DOCUMENT CHANGE NOTICE (DCN)

REASON FOR CHANGE: First article improvements.

0970268-B-2-H

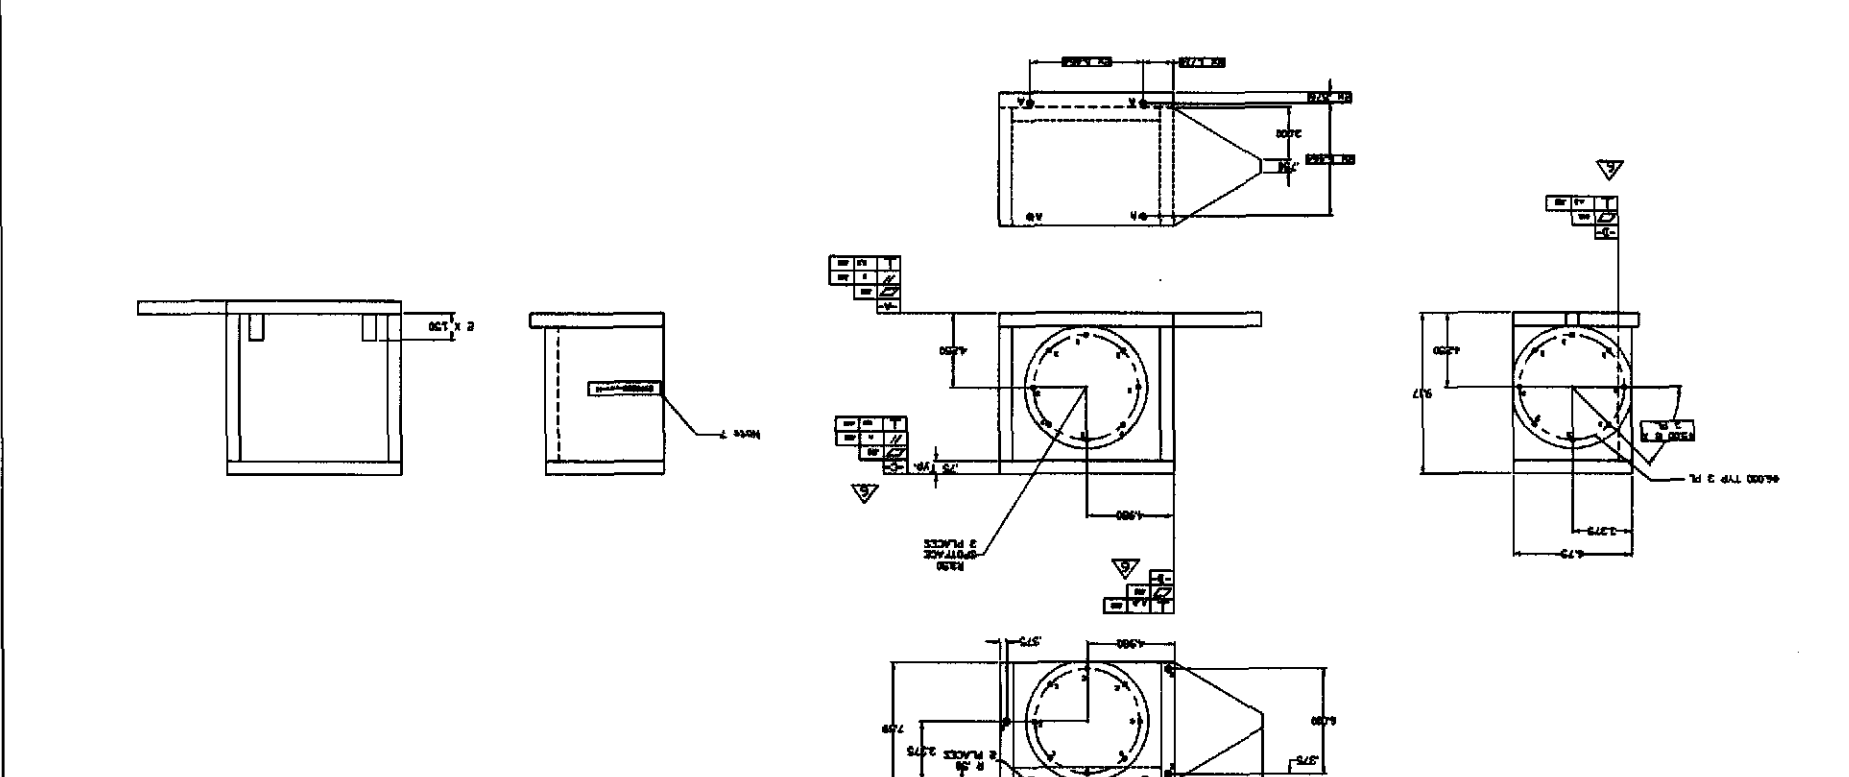
D970268 - Change E INSERTS FROM 10-32 TO 1/4-20. Add MARKING

CALIFORNIA INSTITUTE OF TECHNOLOGY
 PASADENA, CALIFORNIA 91125
 D9170279-C-H

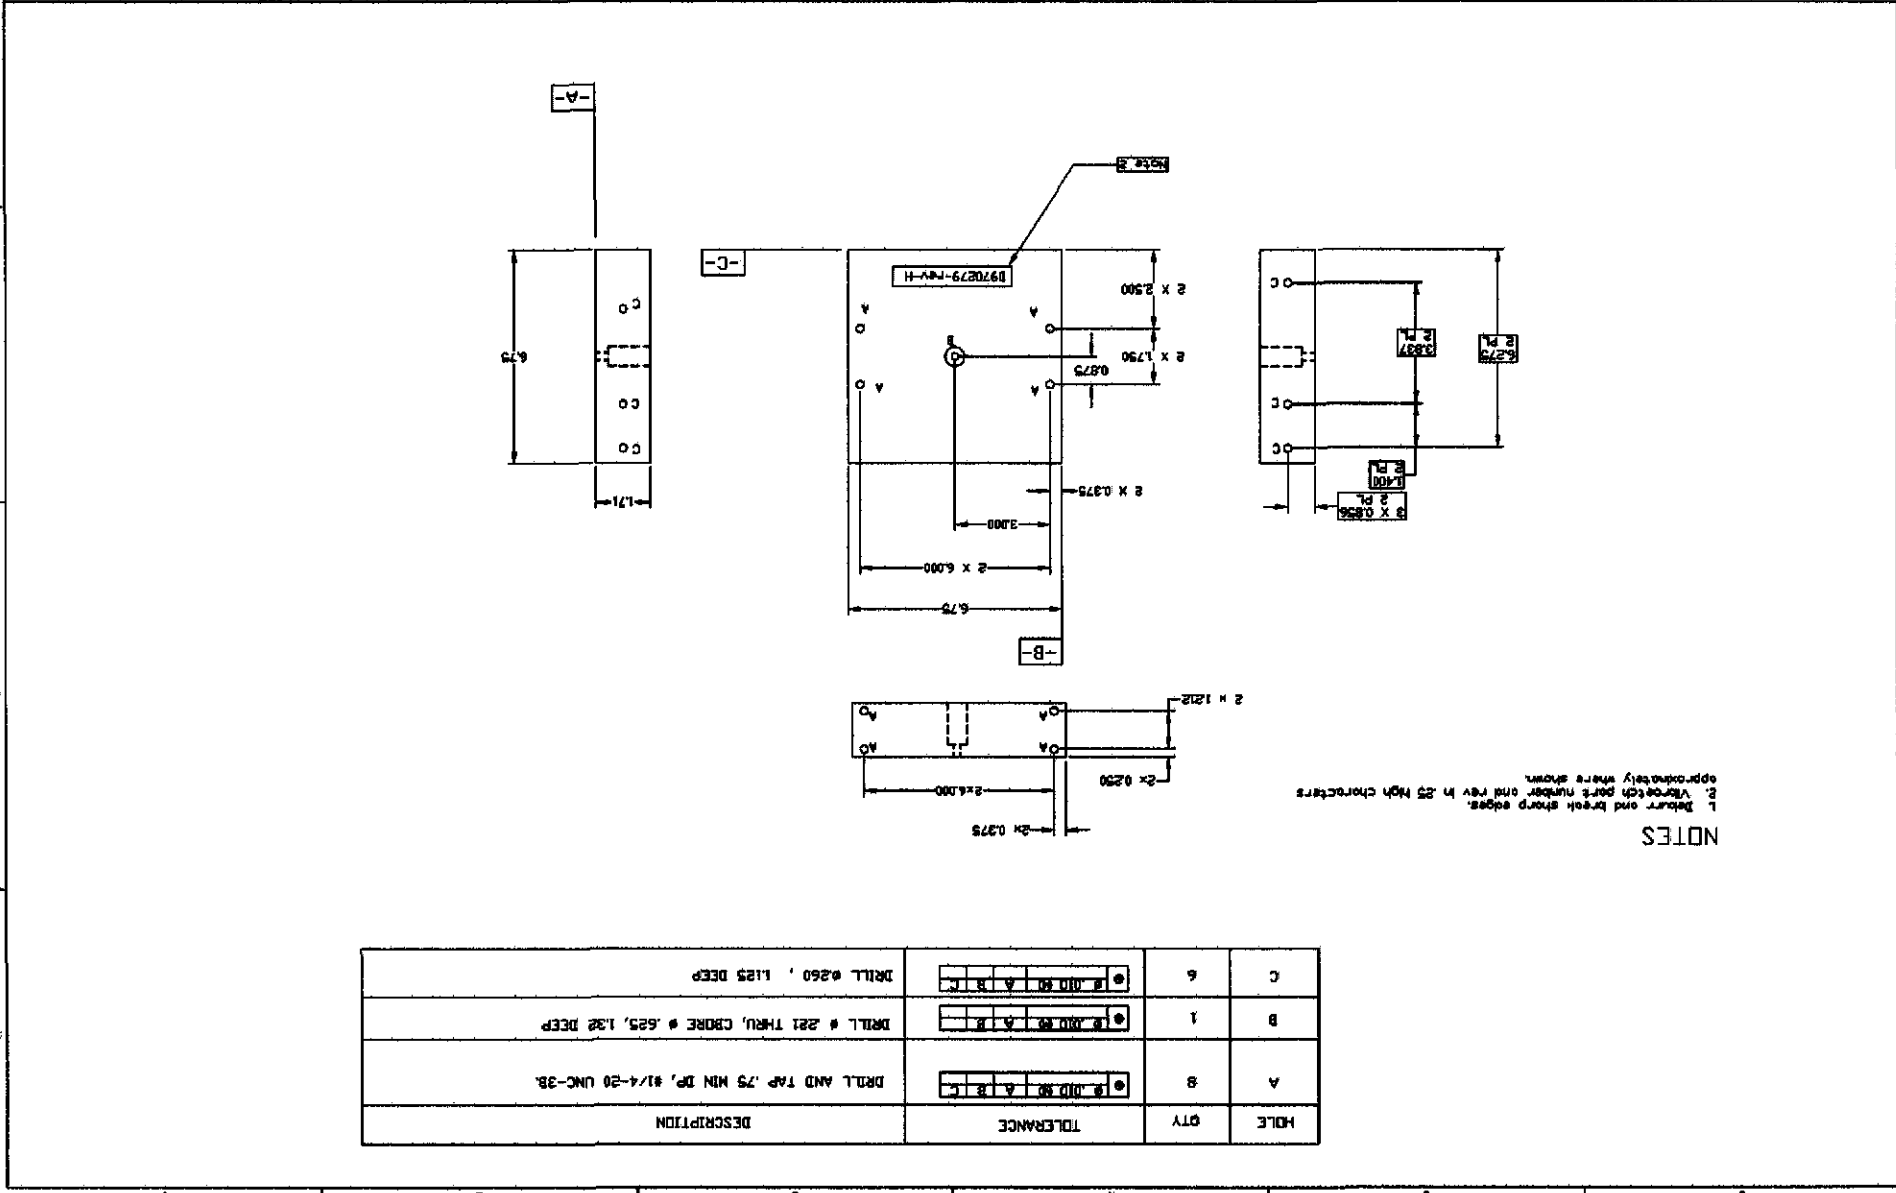
D970279 - Add 6 C holes FOR LOCKING. Add MARKING

DRAWING TITLE: PERM. SUPPORT PLATE
 PROJECT: CALIFORNIA INSTITUTE OF TECHNOLOGY
 DRAWING NO.: D 970288-C-H
 SHEET NO.: 1 OF 1

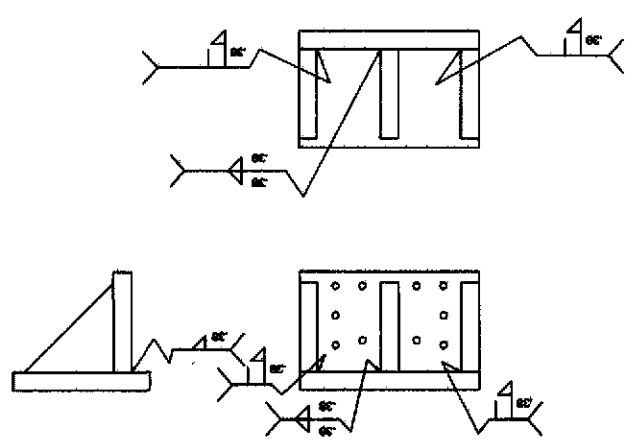
D970288 - Add 2 A holes, Add MARKING

SCALE FULL		SHEET 1 of 1		D980303-A-H	
DRAWN BY: A-HAND		DATE: 5-98		SMITH 6-98	
CHECKED BY: [blank]		DATE: [blank]		[blank]	
TITLE: FLOOR PLAN		PROJECT: PFM STAY CLEAR ZONE		CALIFORNIA INSTITUTE OF TECHNOLOGY	
MATERIALS LIST		PARTS AND MATERIAL LIST		REF ID: [blank]

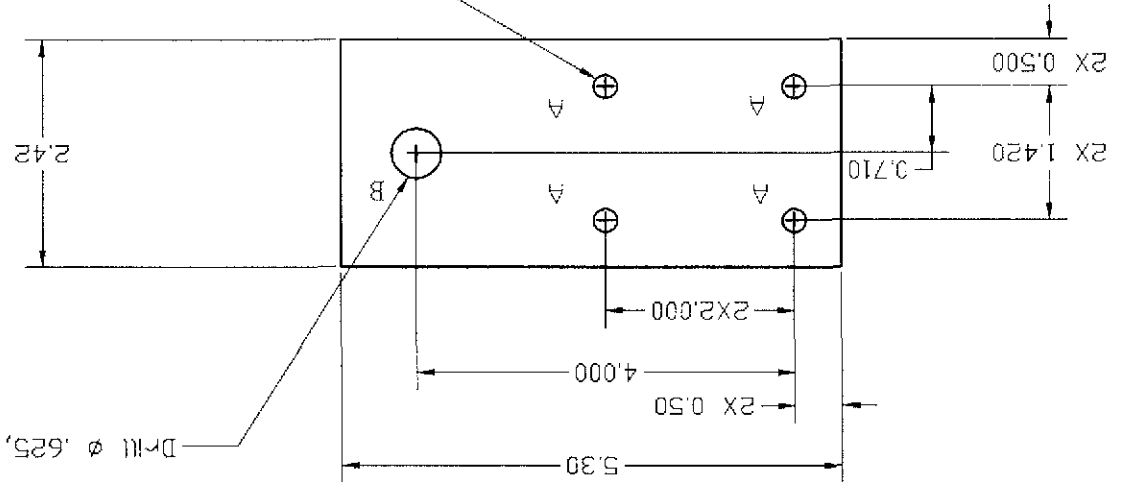
D970303 - Rebase
